UNITED STATES OF AMERICA  
NUCLEAR REGULATORY COMMISSION

DOCKET NO. 50-289  
LICENSE NO. DPR-50

Operating License No. DPR-50  
Docket No. 50-289  
Technical Specification Change Request No. 70

Technical Specification Change Request No. 70

Figure 2.1-2

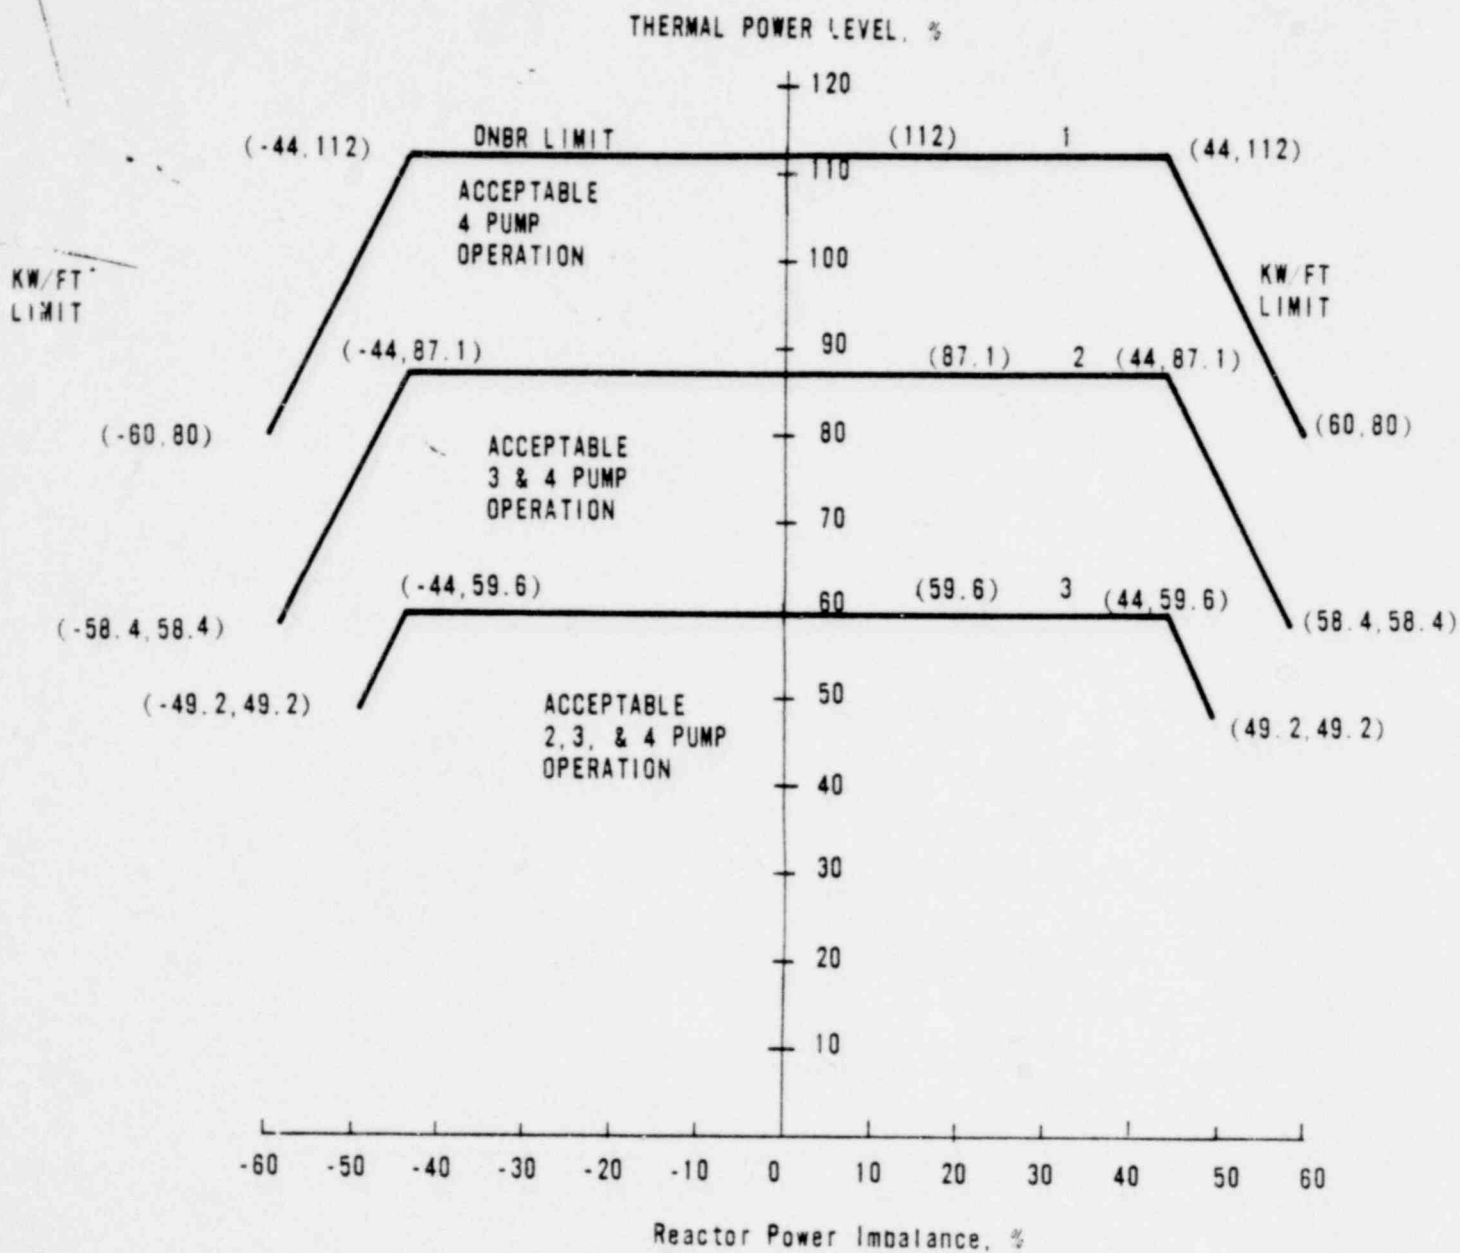
The licensee requests that the attached changed pages replace pages 2-3, 2-6, and 3-34, through 3-36a and Figures 2.1-2, 2.3-2 and 3.5-2A through 3.5-2H. Figures 3.5-2I through 3.5-2M are to be deleted.

The curve of Figure 2.1-1 is the most restrictive of all possible reactor coolant pump-maximum thermal power combinations shown in Figure 2.1-2. The curves of Figure 2.1-3 represent the conditions at which a minimum DNBR of 1.3 is predicted at the maximum possible thermal power for the number of reactor coolant pumps in operation or the local quality at the point of minimum DNBR is equal to 22 percent, (3) whichever condition is more restrictive.

Figure 2.3-2

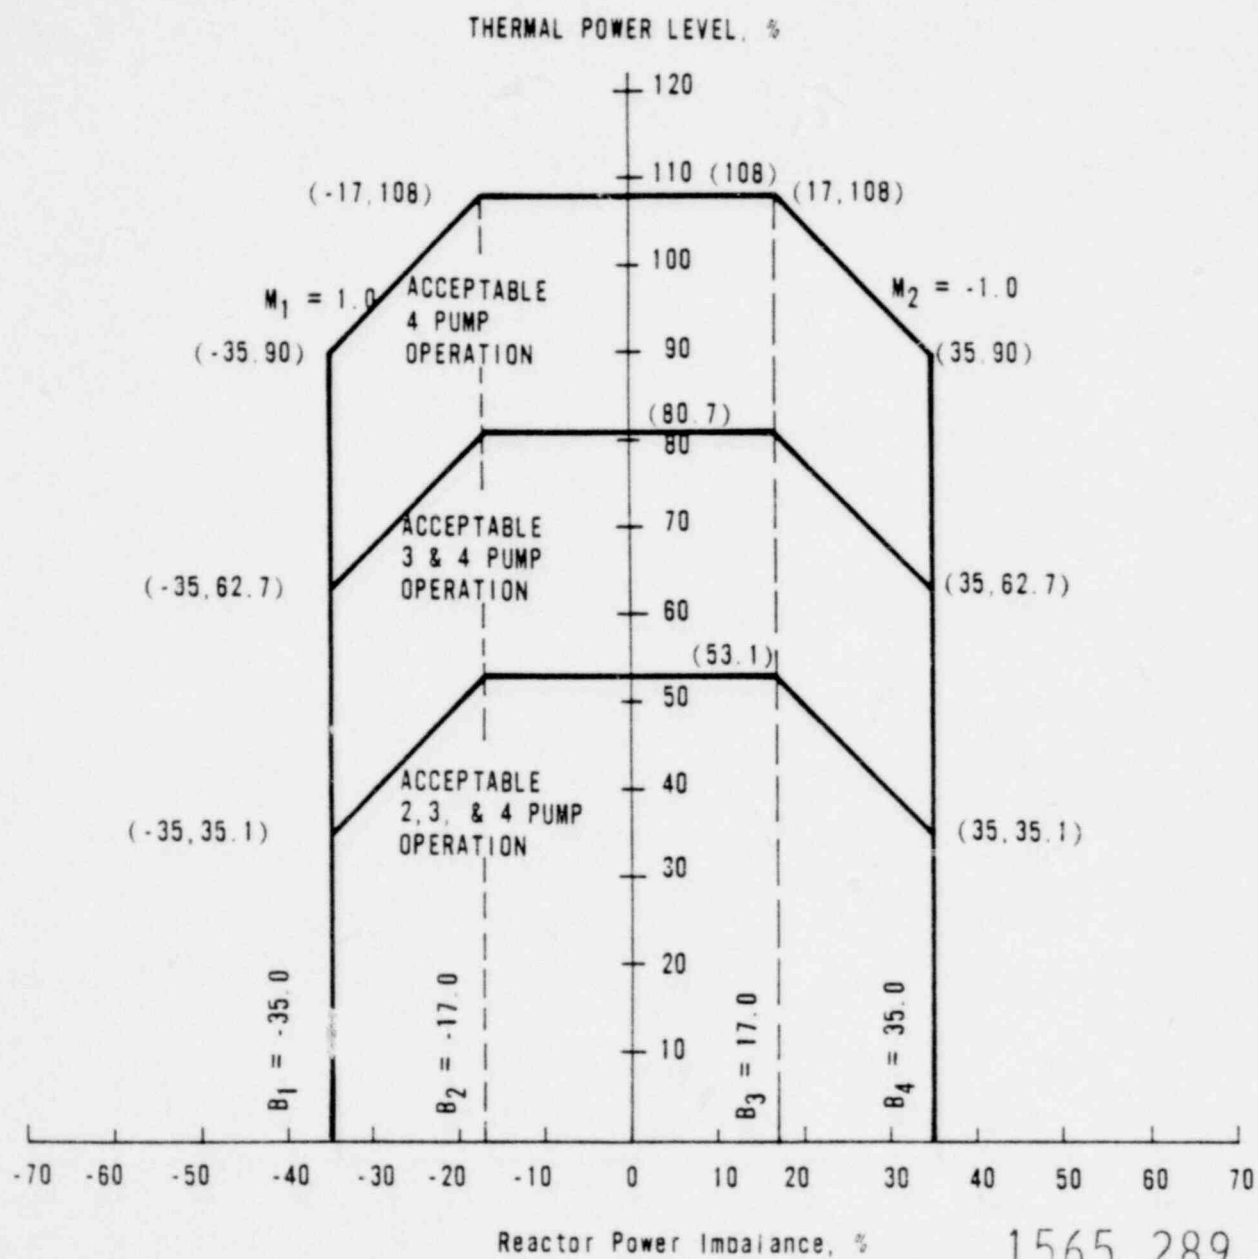
The power-imbalance boundaries are established in order to prevent reactor thermal limits from being exceeded. These thermal limits are either power peaking Kw/ft limits or DNBR limits. The reactor power imbalance (power in the top half of the core minus power in the bottom half of core) reduces the power level trip produced by the power-to-flow ratio so that the boundaries of Figure 2.3-2 are produced. The power-to-flow ratio reduces the power level trip and associated reactor power/reactor power-imbalance boundaries by 1.08 percent for a one percent flow reduction.

Figure 3.5-2A

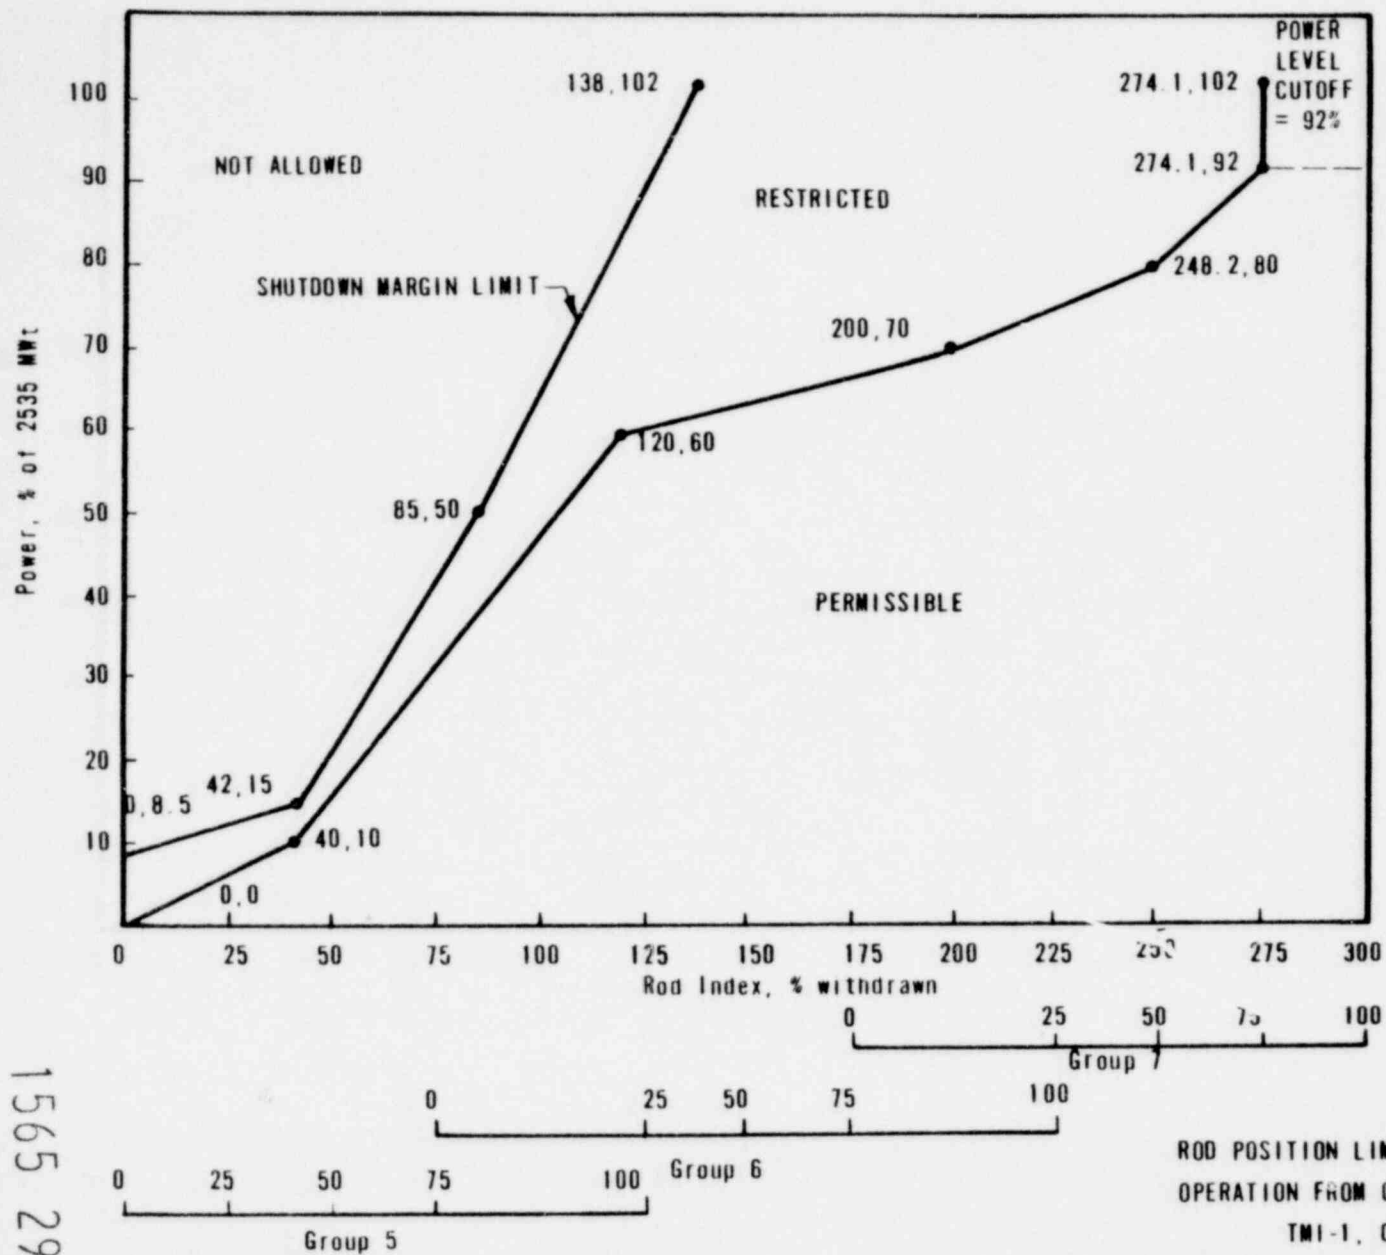
2. The control rod group withdrawal limits (Figures 3.5-2A, 3.5-2B, 3.5-2C, 3.5-2D, and 3.5-2H, shall be reduced 2 percent in power for each 1 percent tilt in excess of the tilt limit.

The Rod index versus Allowable Power curves of Figures 3.5-2A, 3.5-2B, 3.5-2C, 3.5-2D, and 3.5-2H describe three regions. These three regions are:

Figure 3.5-2E

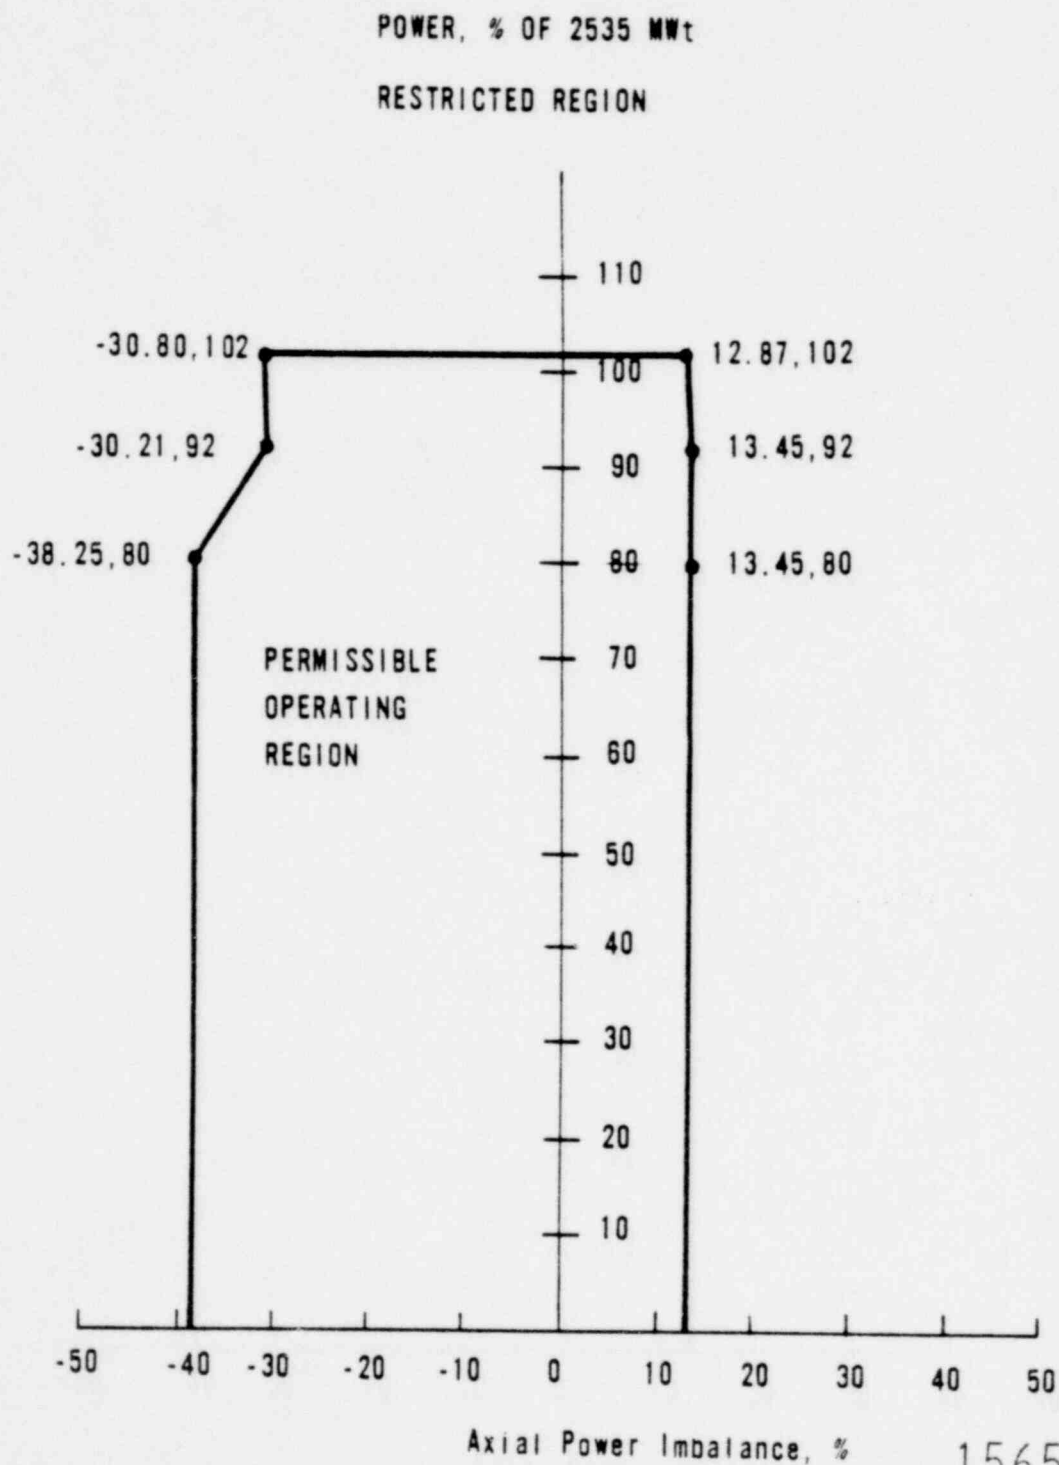
3. The operational imbalance limits (Figure 3.5-2E, and 3.5-2F) shall be reduced 2 percent in power for each 1 percent tilt in excess of the tilt limit.

The power-imbalance envelope defined in Figures 3.5-2E, and 3.5-2F is based on LOCA analyses which have defined the maximum linear heat rate (see Figure 3.5-2G such that the maximum clad temperature will not exceed the Final Acceptance Criteria (2200F). Operation outside of the power imbalance envelope alone does not constitute a situation that would cause the Final Acceptance Criteria to be exceeded should a LOCA occur. The power imbalance envelope represents the boundary of operation limited by the Final Acceptance Criteria only if the control rods are at the withdrawal/insertion limits as defined by Figures 3.5-2A, 3.5-2B, 3.5-2C, 3.5-2D, 3.5-2H, and if quadrant tilt is at the limit. Additional conservatism is introduced by application of:

Figure 3.5-2G

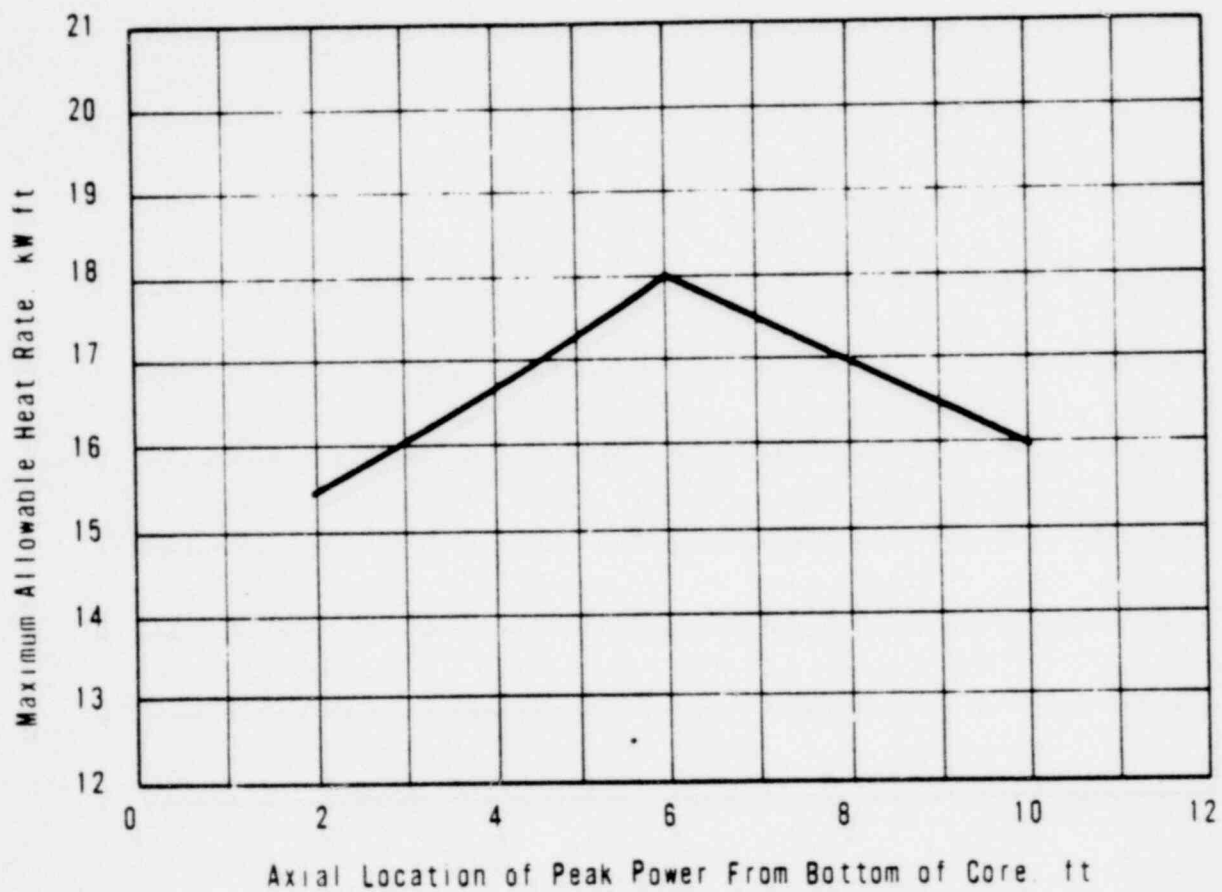
- 3.5.2.7 A power map shall be taken at intervals not to exceed 30 effective full power days using the incore instrumentation detection system to verify the power distribution is within the limits shown in Figure 3.5-2G.
